HISTORIC AND DESIGN REVIEW COMMISSION

October 05, 2022

HDRC CASE NO: 2022-452
ADDRESS: 223 E CAROLINA ST
LEGAL DESCRIPTION: NCB 3010 BLK 8 LOT 15
ZONING: RM-4, H
CITY COUNCIL DIST.: 1
DISTRICT: Lavaca Historic District
APPLICANT: Alan Yoshida
OWNER: Alan Yoshida
TYPE OF WORK: Post-work approval of demolition of accessory, construction of a carport with shipping container, construction of a detached two-story accessory
APPLICATION RECEIVED: August 22, 2022
60-DAY REVIEW: Not applicable due to City Council Emergency Orders
CASE MANAGER: Jessica Anderson
REQUEST:

1. Demolish a rear detached one-story two-bay rear garage.
2. Construct a metal and wood carport with metal shipping container.
3. Construct a rear two-story accessory building.

SHEET:
A-3.0

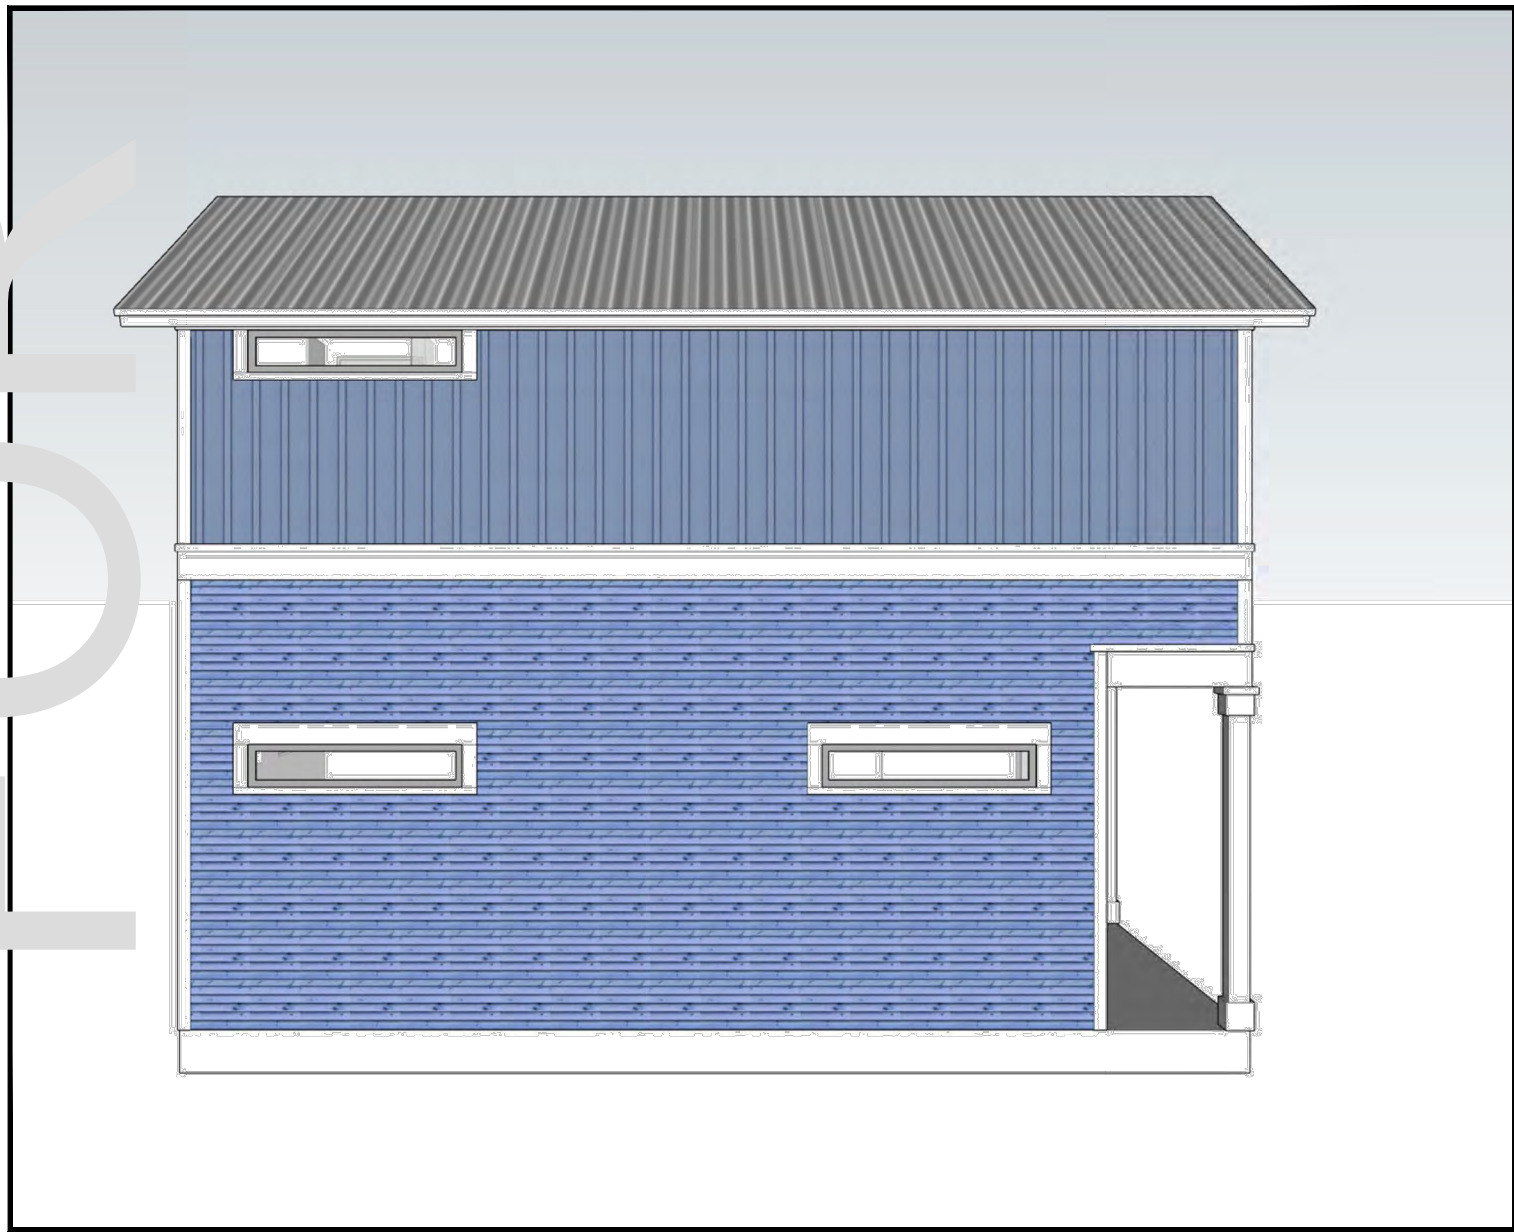
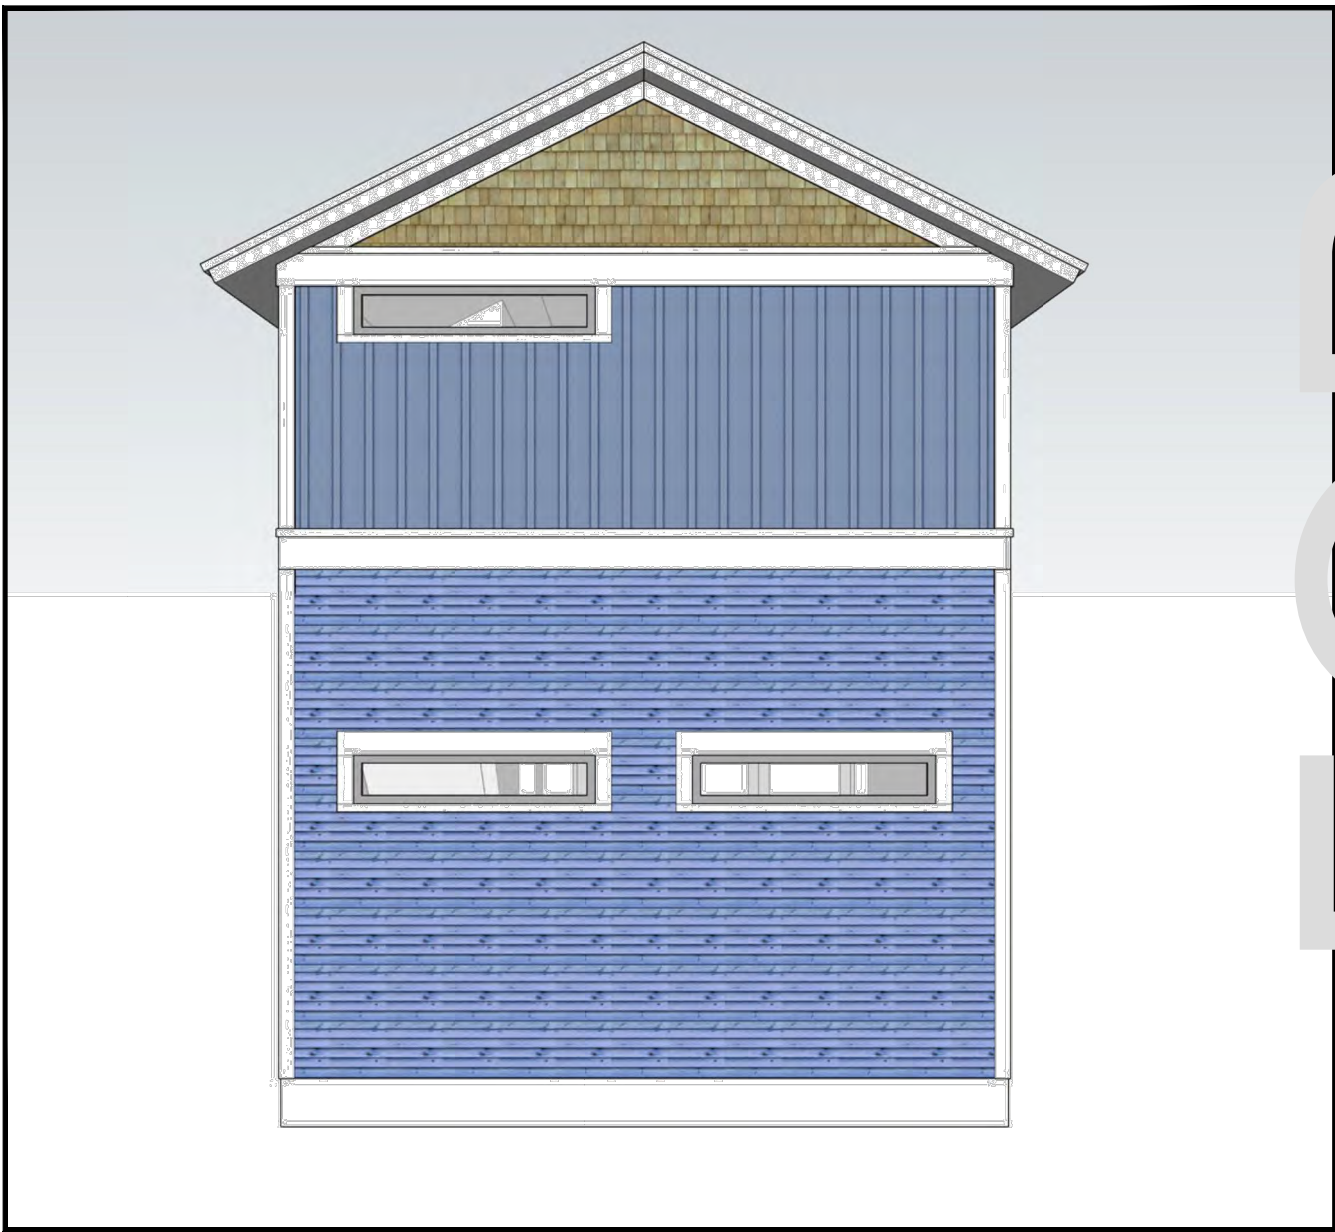
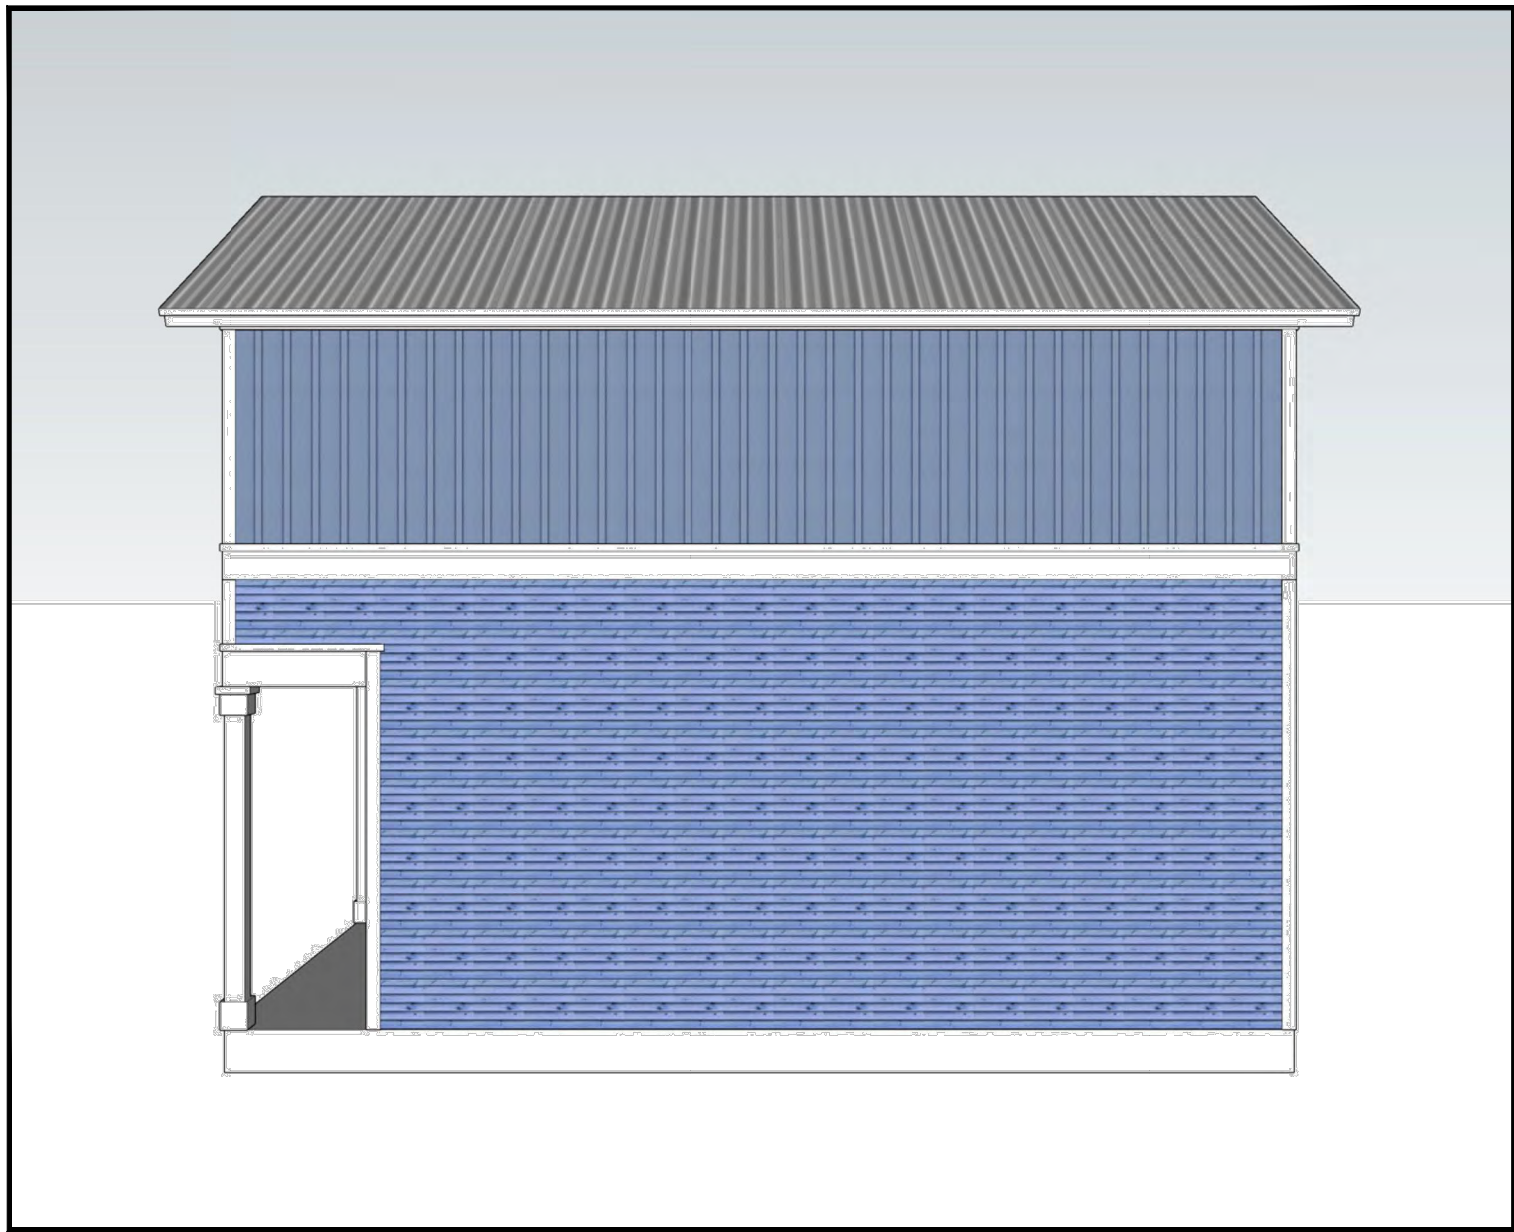
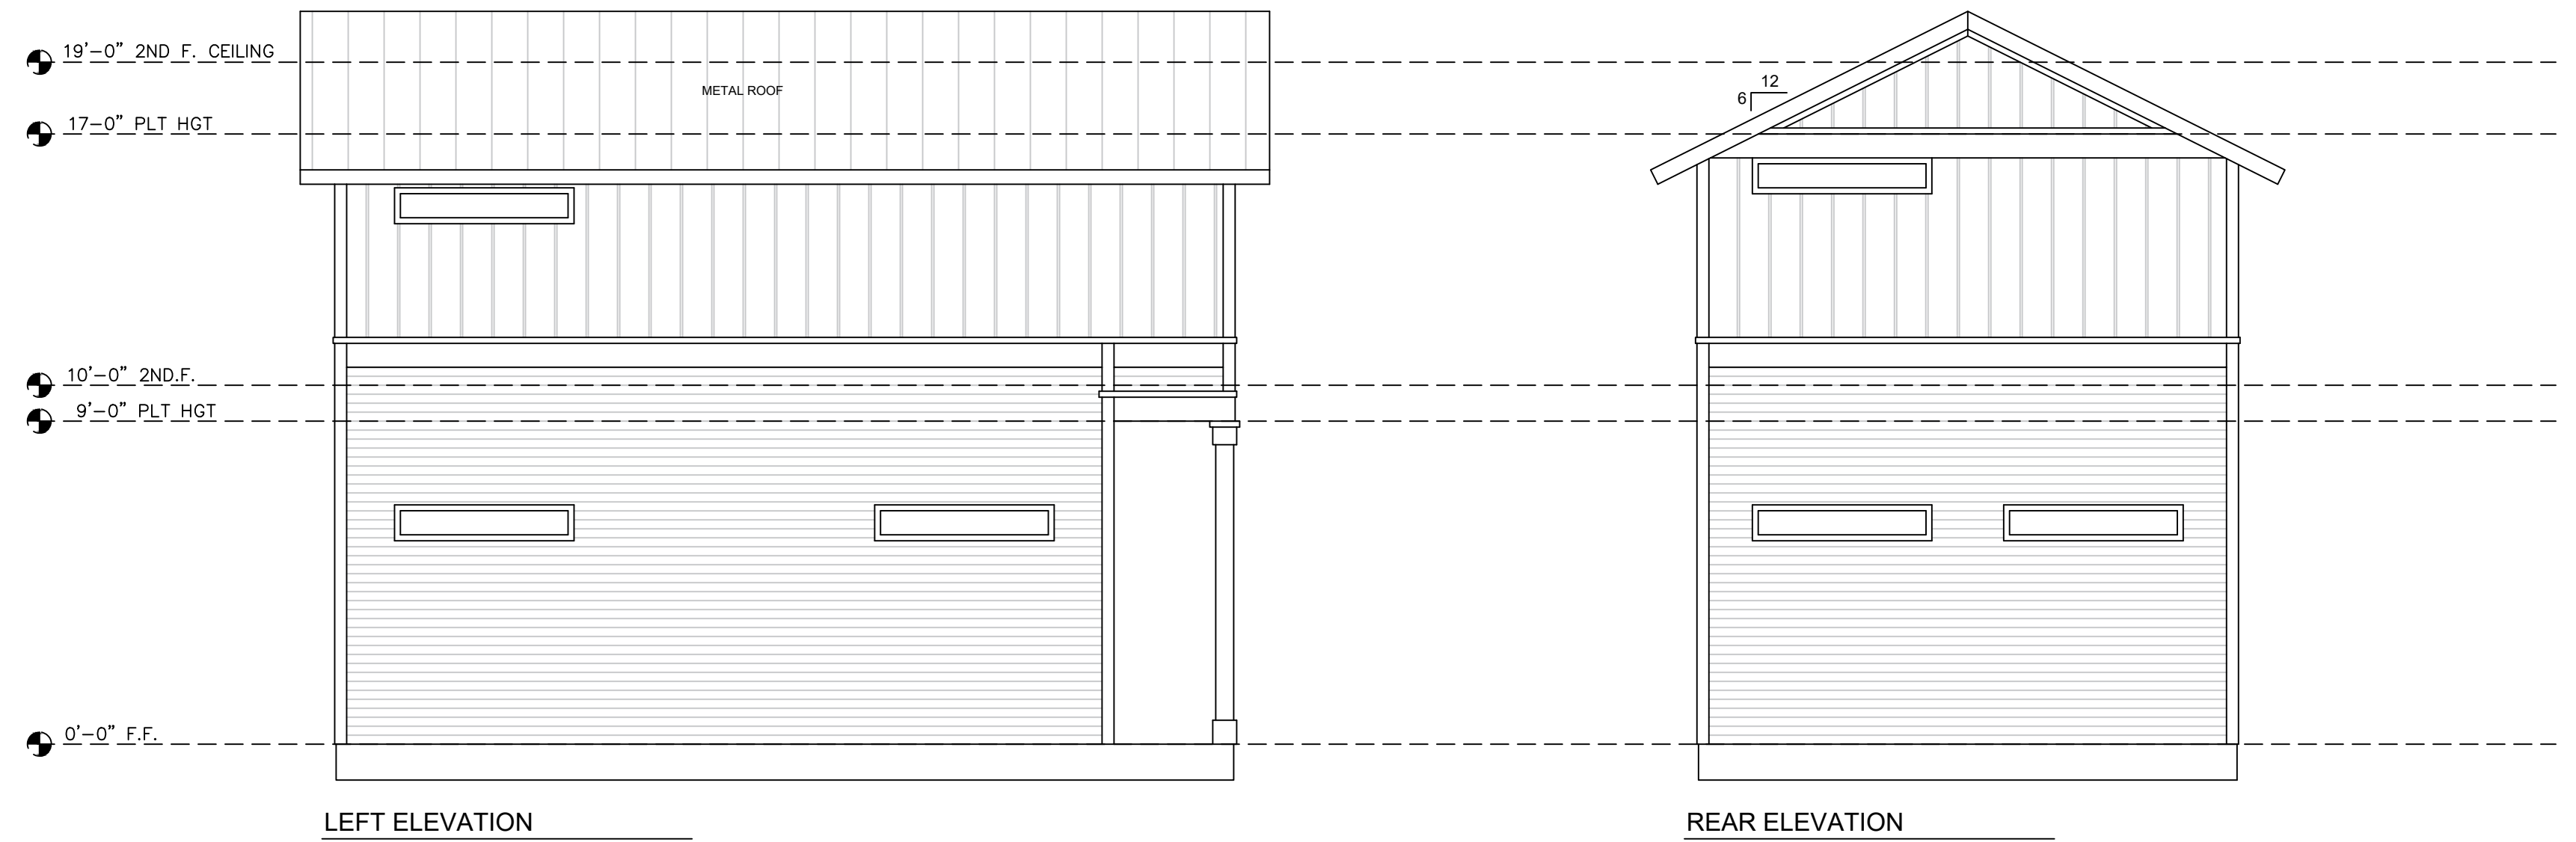
- k. **NEW CONSTRUCTION OF ACCESSORY STRUCTURE:** The applicant requests approval to construct a rear two-story accessory structure. The Guidelines for New Construction 5.A. notes that new garages and outbuildings should be visually subordinate to the primary historic structure in terms of their height, massing, and form, and should be no larger in plan than forty percent of the primary historic structure’s footprint. The existing one-story primary structure features a total footprint of 1,398 square feet. The proposed two-story accessory structures feature a total footprint of 346 square feet, or approximately 25% of the primary structure’s footprint. Accessory structures on the block are predominately single story. Staff finds the proposed height and general massing do not conform to historic design guidelines.

- m. **ARCHITECTURAL DETAILS (MATERIALS):** The Guidelines for New Construction 5.A.iii. and iv. note that new accessory structures should relate to the period of construction of the primary historic structure on the lot through the use of complementary materials and simplified architectural details. The primary structure does not feature a continuous sill line, nor is a sill line characteristic of the Folk Victorian style. The presence of the sill line represents a departure from the period of significance of the primary structure and from use of simplified design as outlined in the guidelines. Staff finds the proposed continuous sill line on the accessory structure does not conform to guidelines.

- n. **WINDOWS:** The applicant proposes ganged fixed-pane windows on the south elevation and fixed clerestory windows on the north and west elevations of the proposed rear accessory structure. There is no fenestration proposed on the east elevation. Windows on the primary historic structure are predominately rectangular one-over-one operable wood windows that appear in ganged pairs or individually. Per Standard Specifications for Windows in Additions and New Construction, new windows on additions should relate to the windows of the primary historic structure in terms of materiality and overall appearance. Windows used in new construction should be similar in appearance to those commonly found within the district in terms of size, profile, and configuration. Staff finds the proposed window profiles are not consistent with these specifications.

Staff recommends approval of item 3, construction of a rear two-story accessory building, based on findings k through n, with the following stipulations:

- i. That the applicant proposes window profiles that have more traditional proportions and configurations (one-over-one) and otherwise meet the Standard Specifications for Windows in Additions and New Construction.
- ii. That the applicant incorporate windows on the east elevation of the accessory structure.
- iii. That the applicant submits materials specifications and details for the proposed windows.
- iv. That the applicant remove the continuous sill line from the design.
- v. The applicant is responsible for meeting all setback and building separation requirements per the zoning code.
